Access Compliance Report Public Rights-of-Way (Curb Ramps)

Main Street: MOCHA_LN Cross Street: LODEN_PASS Location: W

ADA ID: RPRK211104130709 Ramp Type: Type 1 - Perpendicular Initial Pass/Fail: Fail Overall Compliance: No Severity Score: 16

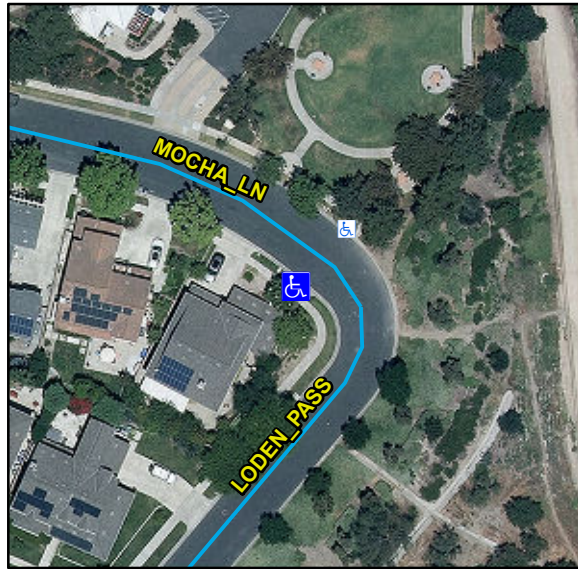
Compliance	Description	Data	Compliance	Description	Data
N/A	Ramp Length (in)	55	N/A	Flare Type LT	
Yes	Ramp Width (in)	48			N/A
No	Ramp Run Slope (%)	9	N/A	Flare Slope LT (%)	N/A
Yes	Ramp Cross Slope (%)	1.8	N/A	Flare Traversable LT	N/A
N/A	Landing Present	N/A	N/A	Flare Type RT	
N/A	Landing Length (in)	N/A			N/A
N/A	Landing Width (in)	N/A	N/A	Flare Slope RT (%)	N/A
N/A	Landing Run Slope (%)	N/A	N/A	Flare Traversable RT	N/A
N/A	Landing Cross Slope (%)	N/A	N/A	DWS Provided	N/A
N/A	Landing Movement Obstructed?	N/A	N/A	DWS Contrast	N/A
	Landing Movement Type	N/A	N/A	DWS Length (in)	N/A
N/A	Landing Shared	N/A	N/A	DWS Full Width	N/A
N/A	Clear Space	N/A	N/A	DWS Offset Left (in)	N/A
N/A	Clear Space To Crosswalk (in)	N/A	N/A	DWS Offset Right (in)	N/A
N/A	Marked Crosswalk 1	No	N/A	Marked Crosswalk 2	N/A
	Crossing 1 Direction	NE		Crossing 2 Direction	N/A
	Marked Crosswalk 1 Width (in)	N/A		Marked Crosswalk 2 Width (in)	N/A

Remove & Replace Entire Ramp.
